Block 7

1. Inconsistent plans:

Proposed west elevation of Building 7 - illustration of hierarchy and variation along length of facade

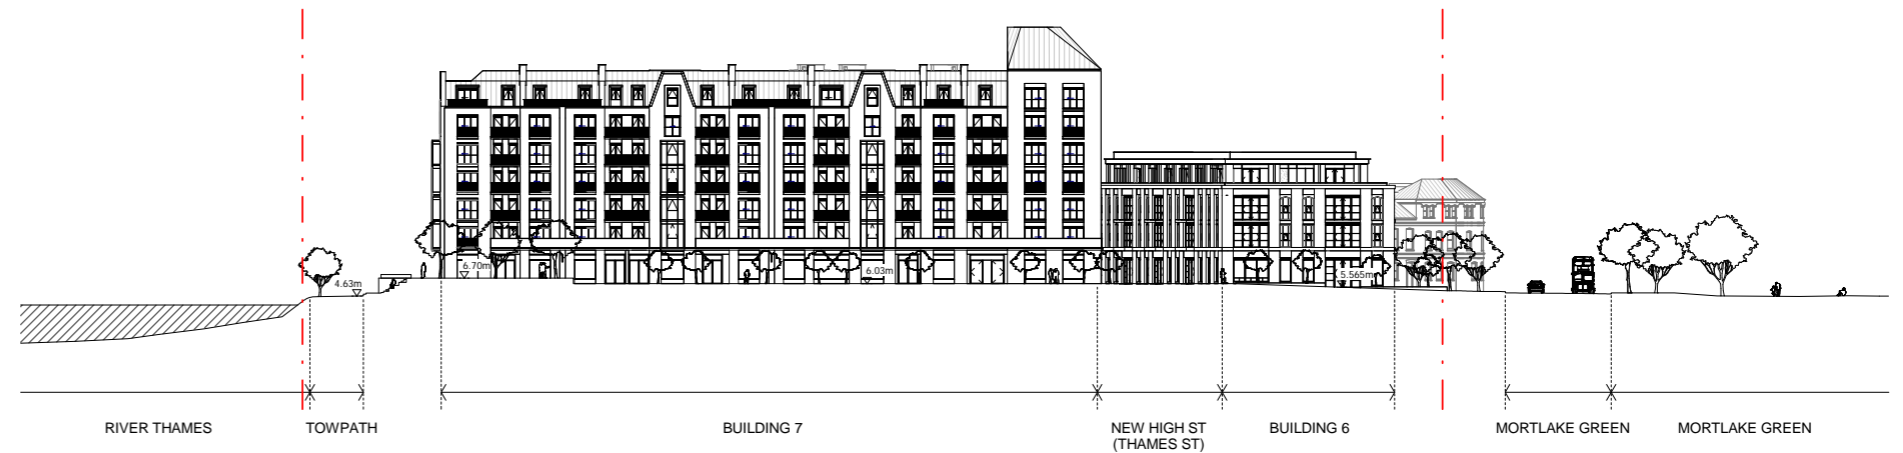
2. Very concerned over the length of the west and east elevations – monotonous. Not enough visual breaks.

We disagree that there is sufficient animation and variation in the long elevations of Building 7. Please refer to our comments on Block 2 - item 2. A variety of different elements (gables, single bays and double bays) at different heights have been used to compose the facades of the mansion buildings. The result is a varied parapet line and depth of façade. The gables and bays have strong vertical emphasis and relief that assists in breaking up the horizontality of the façade – particularly when viewed in perspective.

We believe that the use of the word ‘monotonous’ is not a fair description of the façade. Please refer to the annotated drawing opposite, which should aid in explaining the complexity of the building relief.

Proposed typical floor plan - Buildings 7 and 8

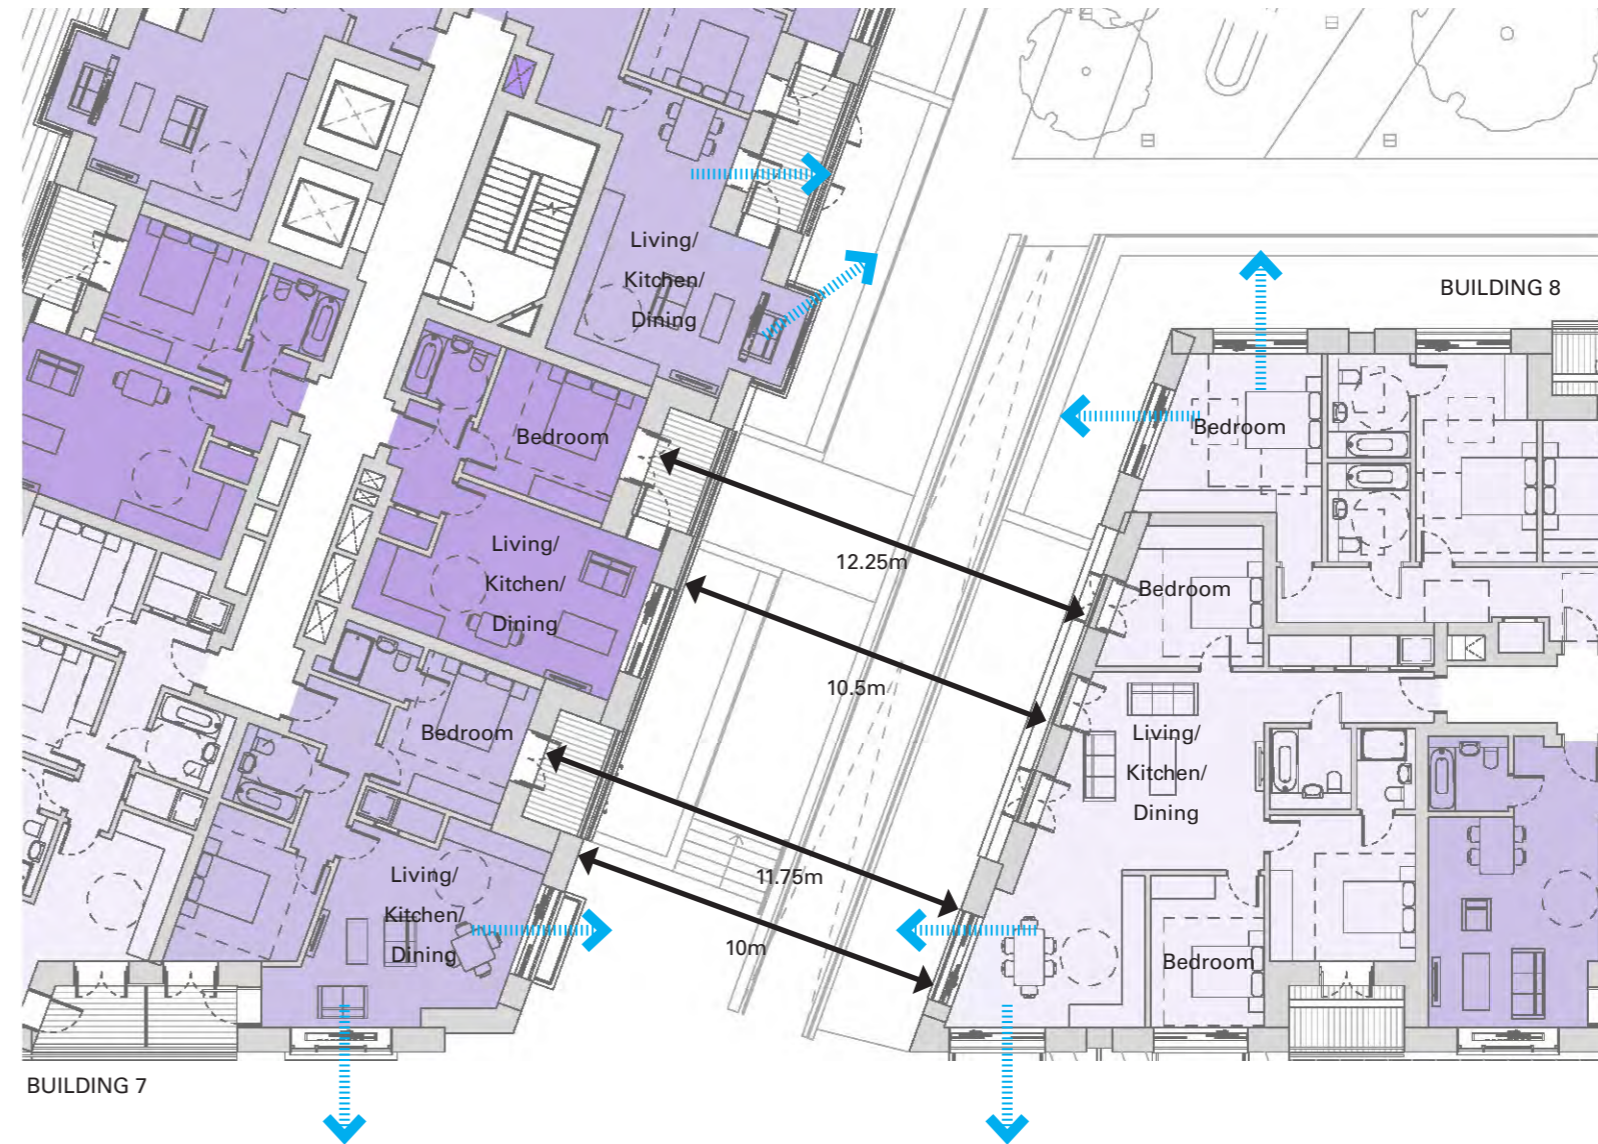
4. Block 8 with 11: Only 15m gap and single aspect. Why acceptable.

5. Block 8 with 7: Only 10m gap. Unacceptable living conditions.

Please see section dedicated to 'Proximity of Buildings'.

Please see section dedicated to 'Proximity of Buildings'.

Proposed ground floor plan - Building 9

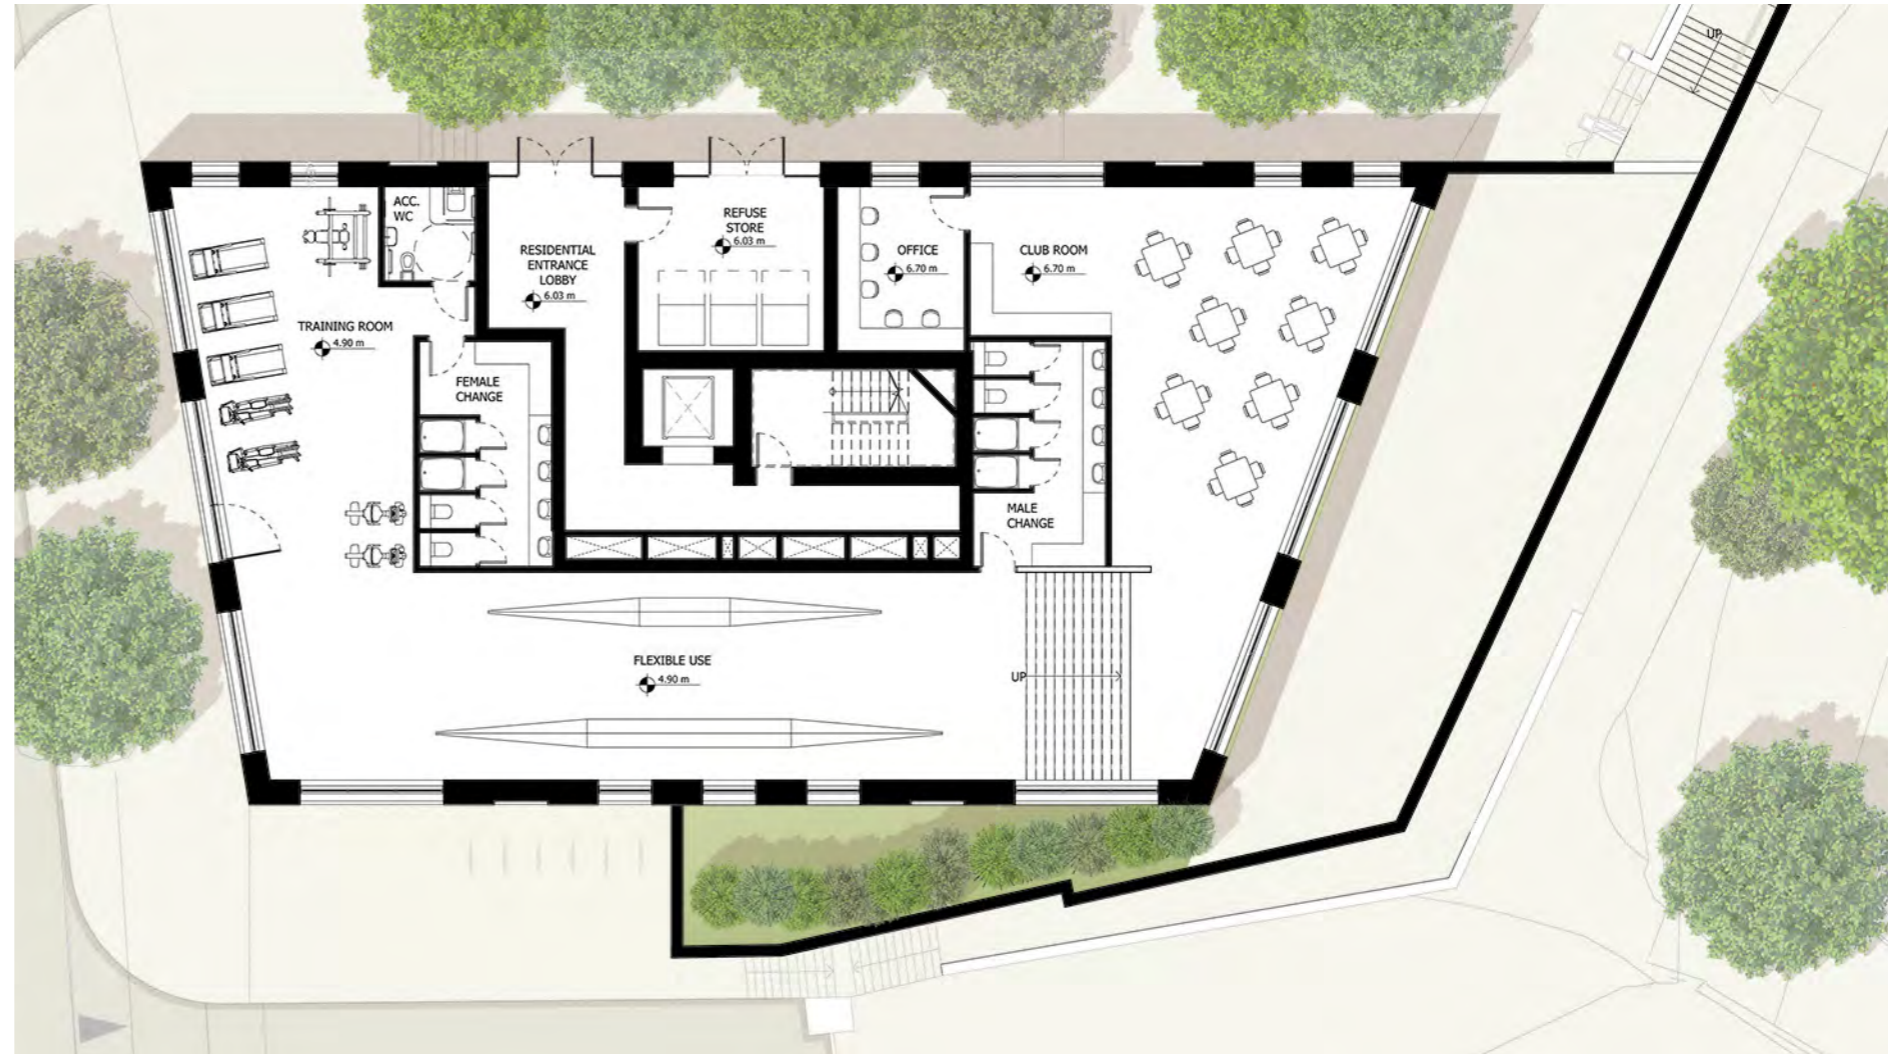
1. Provide updated elevations.
2. Provide section through, showing level changes from floor to river.
3. Removal balustrade at roof level.

4. Ensure plant is at centre of roof level.

The proposal for Building 9 has been altered to respond to comments from the environment agency regarding current and future flood risk. The revised proposal provides a means of defence along the building façade as opposed to within the ground floor of the building. The proposal also incorporates a raised terrace area, beneath which a storage area for rowing boats (or other water sport equipment) is proposed to provide ease of access to the existing slipway. The balustrade at roof level was proposed as a means of edge protection (from risk of falls) to any maintenance personnel when accessing roof top plant. We would not recommend removing this balustrade since this would pose a health and safety risk.

The roof top plant has already been configured in a manner that provides minimal impact to the appearance of the building. The parapet level facing Mortlake High Street masks the roof top plant from view.

Revised north elevation - Building 10

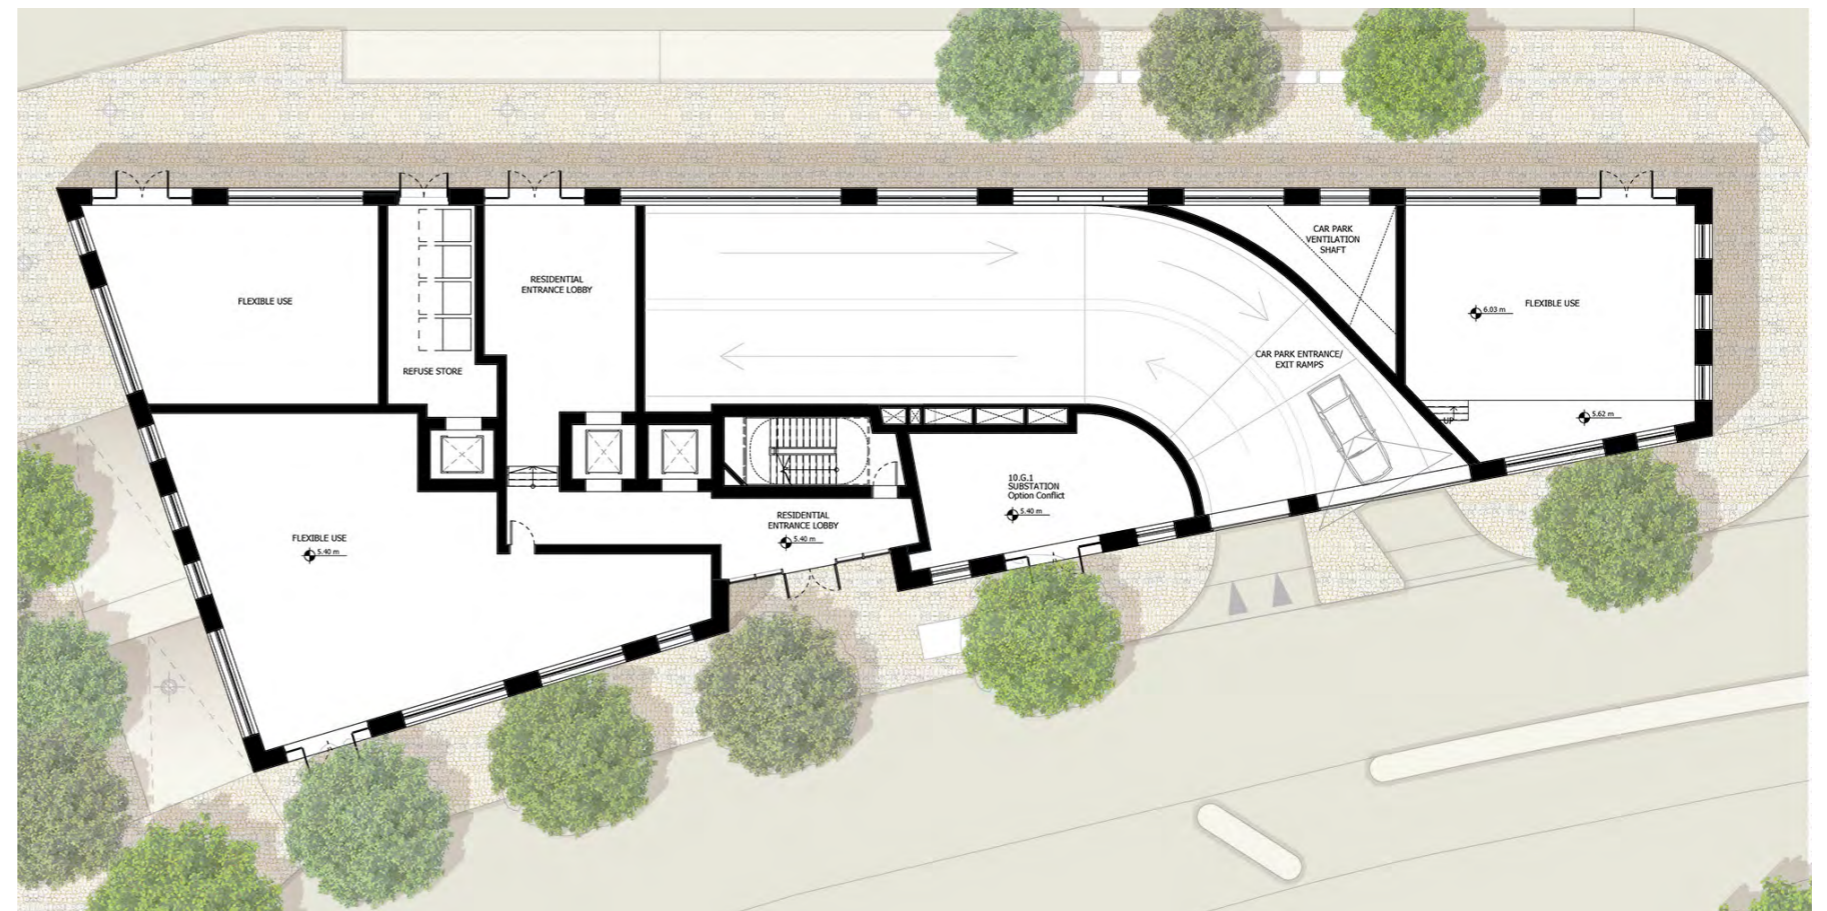
1. North elevation 'dead frontage'.

3. Poor frontage on south elevation – entrance, substation, rear of flexible uses and car park.

The 'dead frontage' is caused by the ramp access to the car park. This access location is constrained by existing highways circumstances and by technical issues relating to the ramps fall and turning radius. Unfortunately, there is very little that can be done to reduce the impact of the ramp (i.e. by moving location of and/or reducing length of the ramp) other than to provide obscured glazing to these openings. The obscured glazing could incorporate advertising and/or public notices and the design of these features could be conditioned.

The ground floor level of this building is constrained by technical requirements (see response to item 1), however we have endeavoured to introduce amendments to increase width of glazing to flexible use units.

Proposed typical floor plan - Buildings 10, 11 and 12

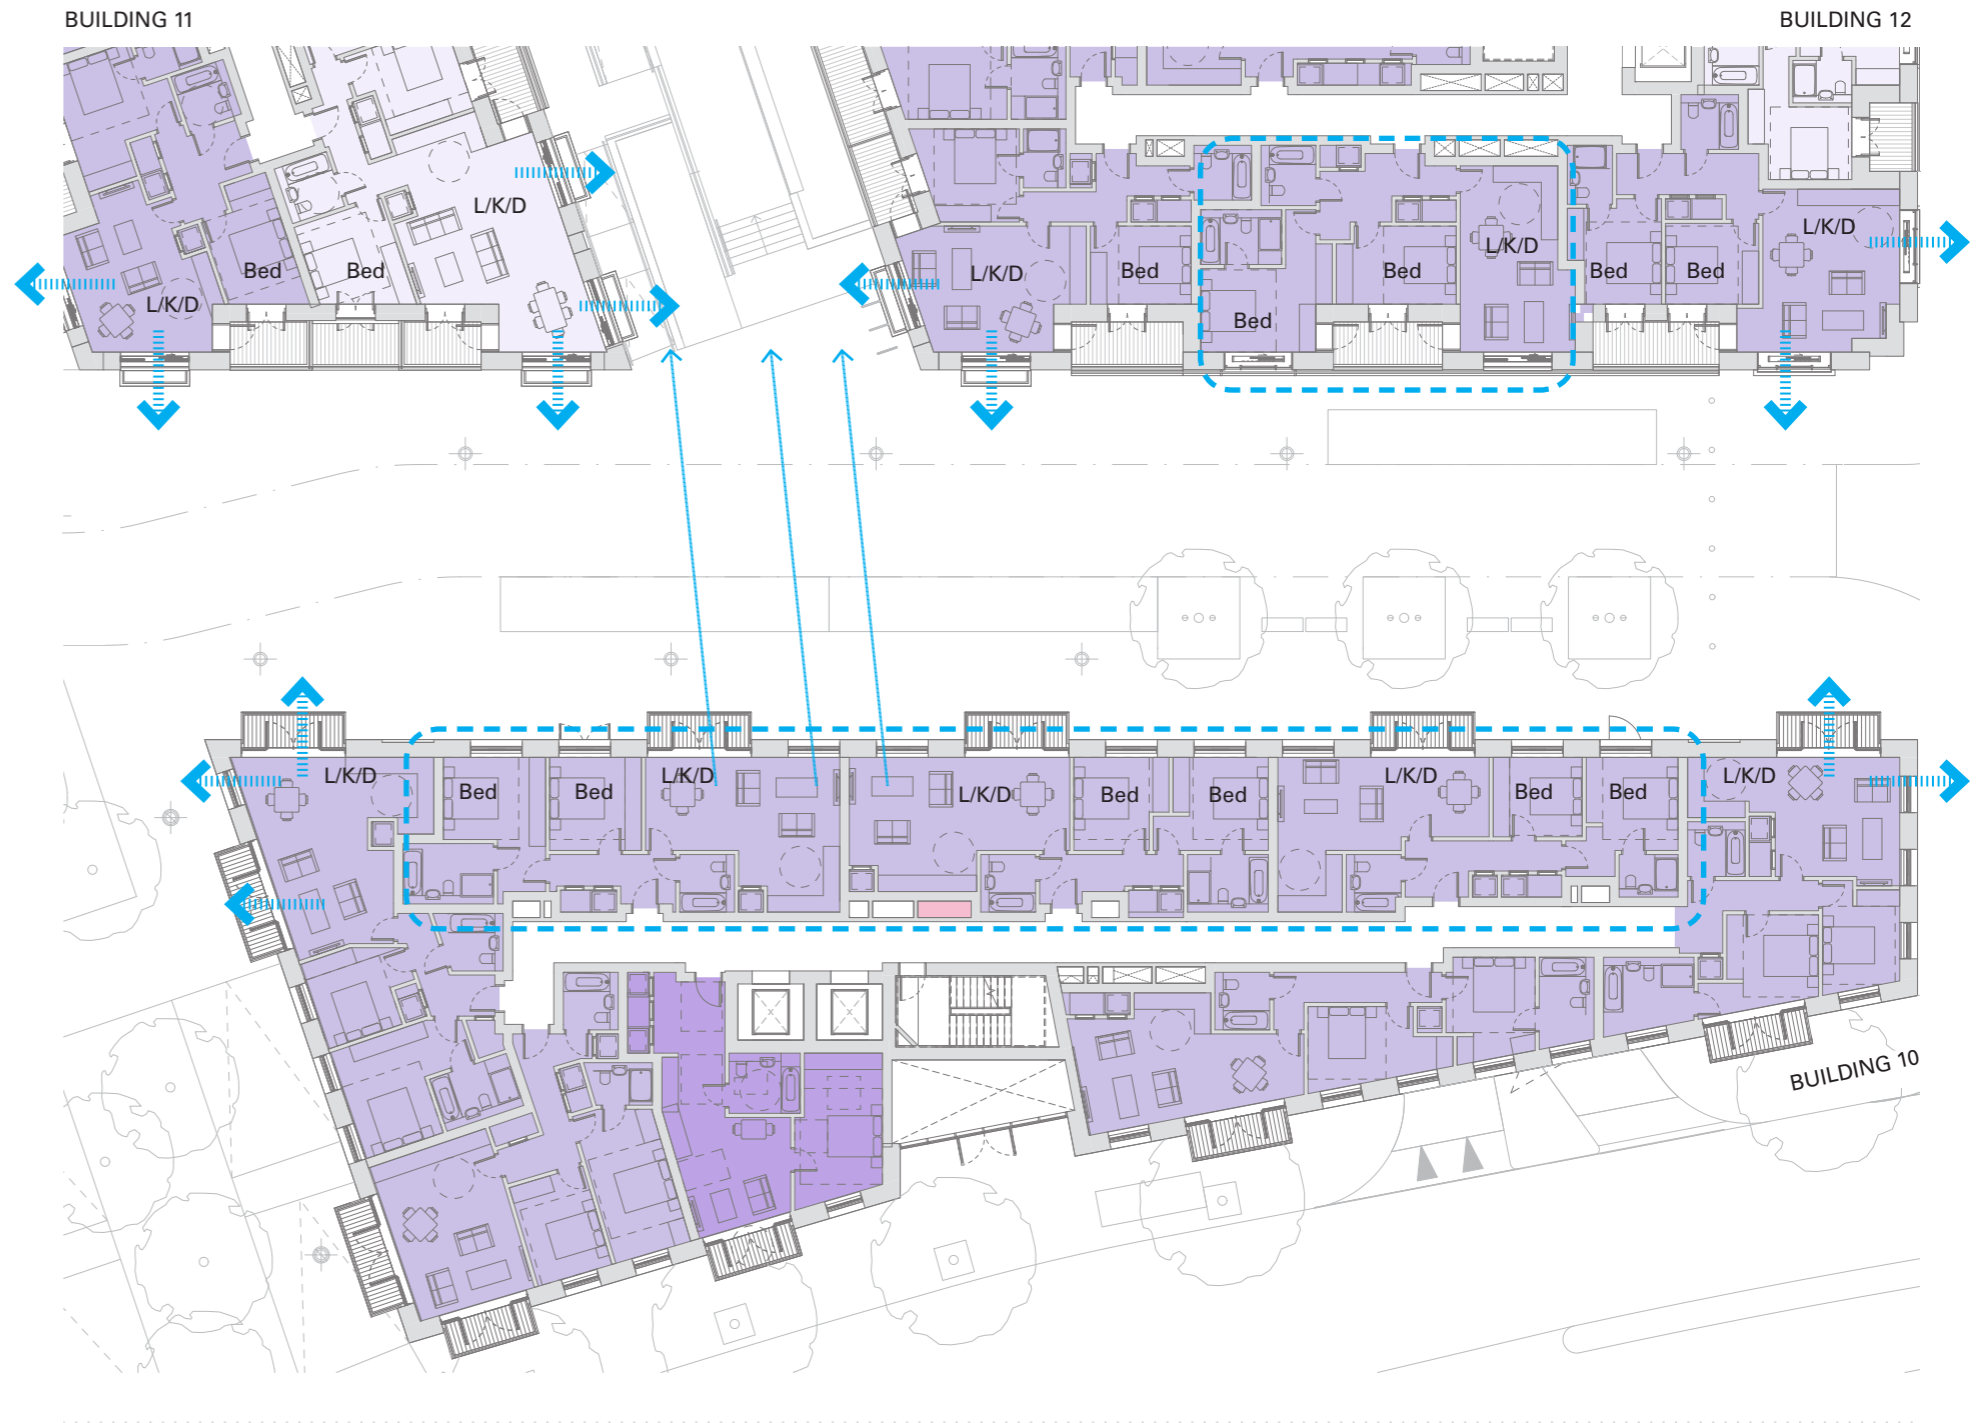
- Block 10 with 11 and 12; only 13m and incorporates north facing single aspect units.

- Surrounding blocks (5, 11, 12 and 9) are only 13.5 – 15m from the facades. All such distances fall below the 20m standard for privacy levels – how will the scheme prevent unacceptable overlooking, and ensure that flats are not overbearing to future occupants.

Please see section dedicated to 'Proximity of Buildings'.

Please see section dedicated to 'Proximity of Buildings'.
